## 13 Air quality

### 13.2 Response to submissions

Comparison of Dunedoo, Gulgong and MET01 wind roses - 9am and 3pm

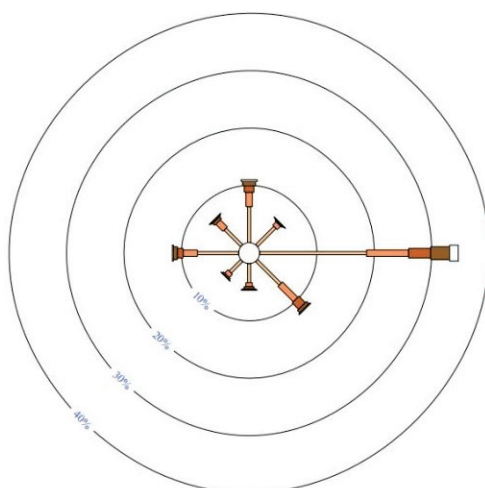
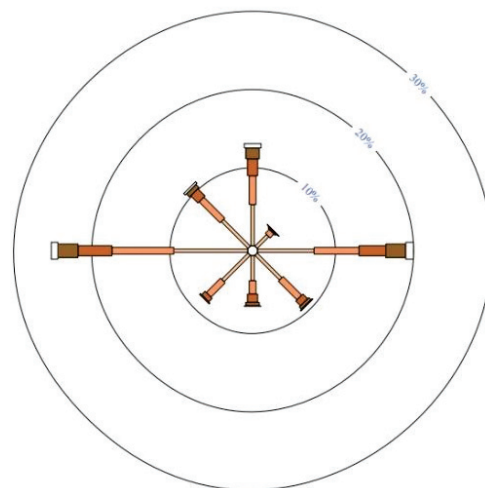
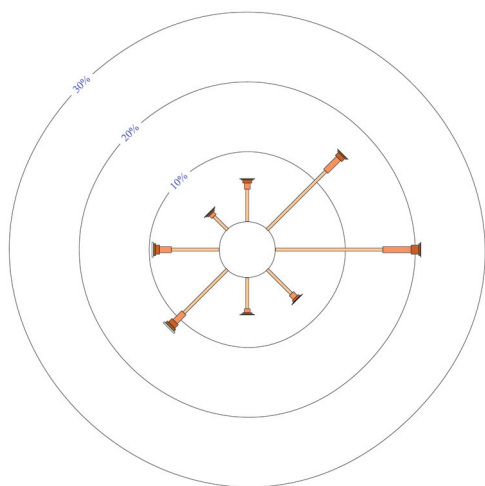
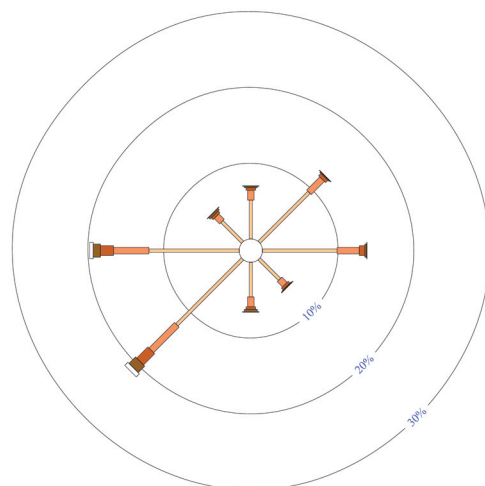
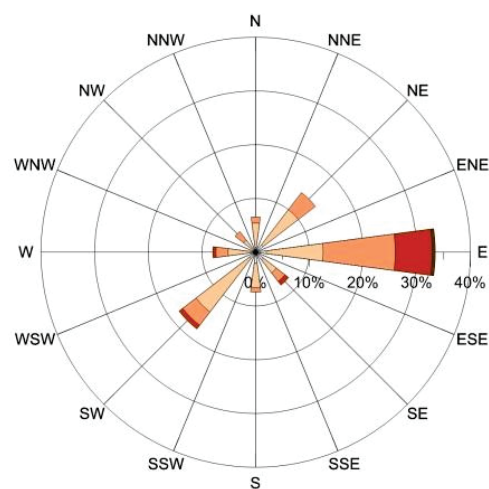
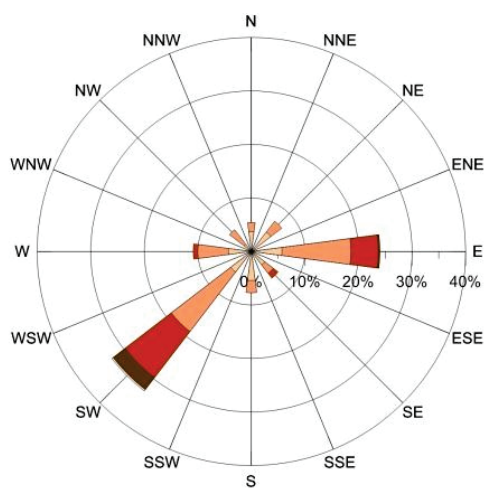
- wind direction: predominant winds are from the west and south-west and not from the east as reported in the EA;
- meteorological stations: data from MET 02 were incomplete and do not satisfy modelling requirements; wind data from Dunedoo Post Office, which shows wind from the west and north-west, was not used; and the EA does not state why MET 02 is at the south-east corner of pit B;

- sampling period: 23 August 2011 to 3 November 2011 was not enough to represent wind directions and strengths; and the EA does not consider if a 12-month modelling period represents typical weather, particularly given the sampling period was during an “El Nino” [sic];
- data used: the air quality and noise assessments use different meteorological data; and
- data exclusion: data has been selectively excluded to show favourable weather and calculations reduce the impact to Gulgong.

Wind data from the BoM station at Gulgong and Dunedoo was not used in the dispersion modelling. While wind speed and direction are recorded at these locations, observations are only made at 9 am and 3 pm (see Figure 13.1). For an entire calendar year, this equates to 730 hourly observations from a possible total of 8,760 1-hour records. This does not meet the OEH requirement for 90% data completeness.

The 9am and 3pm wind roses from the Dunedoo climate station between January 1965 and September 2010, Gulgong climate station between March 1970 and September 2010 ([www.bom.gov.au/climate/averages/tables/cw\\_064009.shtml](http://www.bom.gov.au/climate/averages/tables/cw_064009.shtml)) and the 9 am and 3 pm wind roses from data recorded at MET01 between November 2010 and November 2011 (Figure 13.1) show the similarities between the three monitoring locations. While there are slight differences between the three stations, the Gulgong station shows a good correlation with the MET01 wind roses. Whereas the dominant wind in Dunedoo at 3 pm is westerly, while the dominant wind at MET01 at 3 pm is south-westerly. The wind roses reinforce the suitability of the MET01 dataset, which was recorded in the centre of the mining area against long-term regional wind data. The prediction of dust impacts using the MET01 data set is considered valid for downwind receptors in Gulgong.
